**Reworld Marion, Inc.**  
4850 Brooklake Road NE  
PO Box 9126  
Brooks, OR 97305  
Tel (503) 393-0890  
Fax (503) 393-9714

*RE: Reworld Marion, Inc. – Revised Cleaner Air Oregon Emissions Inventory Submittal*

## **RESPONSE TO SPECIFIC COMMENTS FROM OREGON DEQ**

Figure 1. Wind Speed and Direction During Summer Months

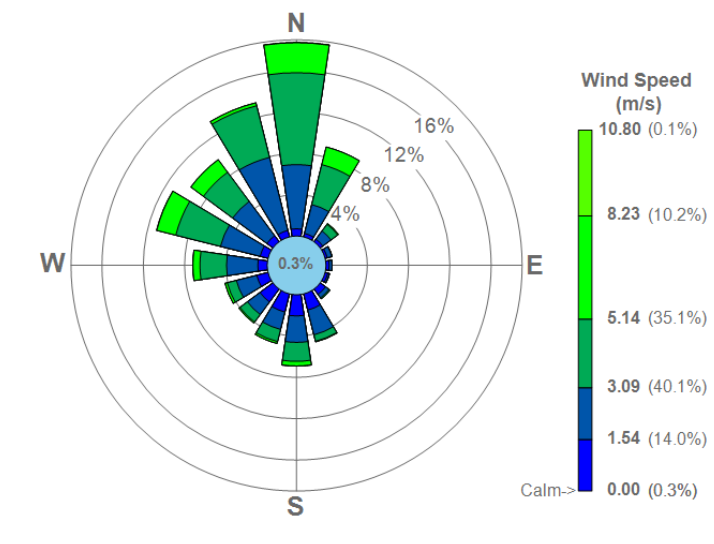
The St. Louis Ponds County Park is located approximately 4.72 miles north of RMI. Prevailing winds near RMI and the St. Louis County Park originate normally from the south to the north. These prevailing wind patterns primarily occur during rainy months, in which the vast majority of particulate bounded matter and potential soluble mercury vapor, would be washed out of the plumes from RMI well before reaching the St. Louis Ponds Park. Additionally, as shown in Figure 1 below, during summer months where particulate bounded matter and vaporous emissions are expected to disperse and potentially deposit farther away from RMI due to the absence of rain, the wind patterns shift to primarily originate from the north to south. In these months, the St. Louis Ponds County Park would be upwind of RMI. Lastly, per the mercury speciation data included in Attachment A, mercury that is emitted from RMI is 90 to 95% in the soluble ionic form, with only 5-10% in the elemental vapor form, and less than 1% in the particulate form. Based on these two atmospheric conditions, the St. Louis Ponds County Park would be upwind of RMI during non-weather events where particulate matter could deposit further from RMI; minimal mercury would be present in the plume from RMI near the St. Louis Ponds County Park during weather events; there will be little mercury wet or dry deposition, if any, 4.72 miles away; and any minimal mercury deposition calculated would not impact the risk assessment.
